May 19, 2006

I would like to thank the Department of Energy (DOE) for the opportunity to submit comments on the proposed changes to the ENERGY STAR CFL criteria. The following comments are submitted by CEE in response to the third draft of the criteria. They were developed by the CEE Lighting Committee (Committee) and are supported by the organizations listed below.

### **NEW ISSUES FROM DRAFT 3**

Light Output of Slow-Starting Lamps, Source: BC Hydro Testing

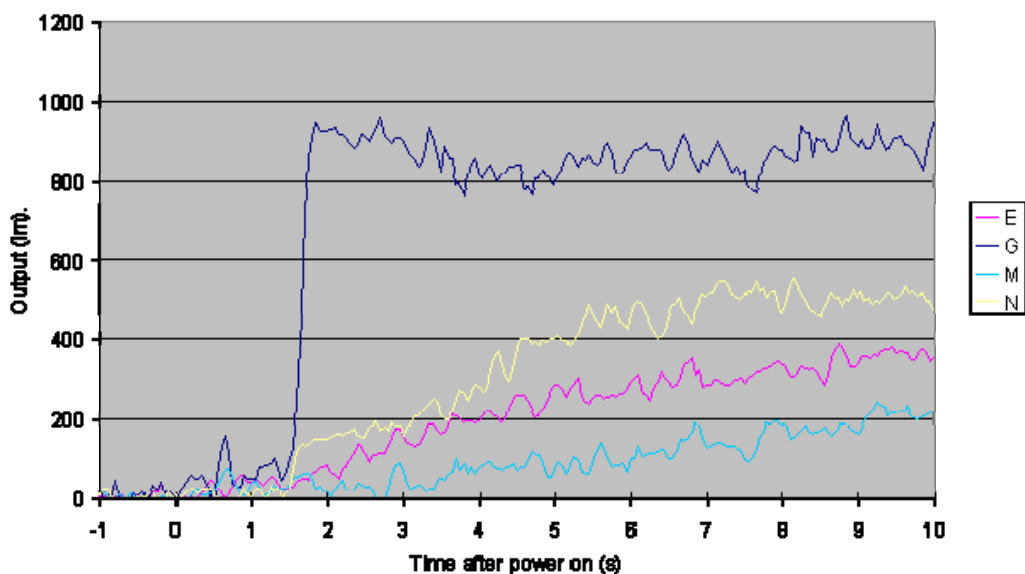
It has come to CEE's attention that there is some uncertainty among testing labs as to the definition of "full start" within the test for starting time. Testing labs do not have a definition of full start to use in their testing of starting time and are uncertain when to "stop the clock." We have provided a chart of slow start CFLs for DOE's reference, and suggest that the Department consider defining this metric to alleviate confusion. We recommend 15% or 20% of full light output as a starting point in the discussion about an appropriate definition.
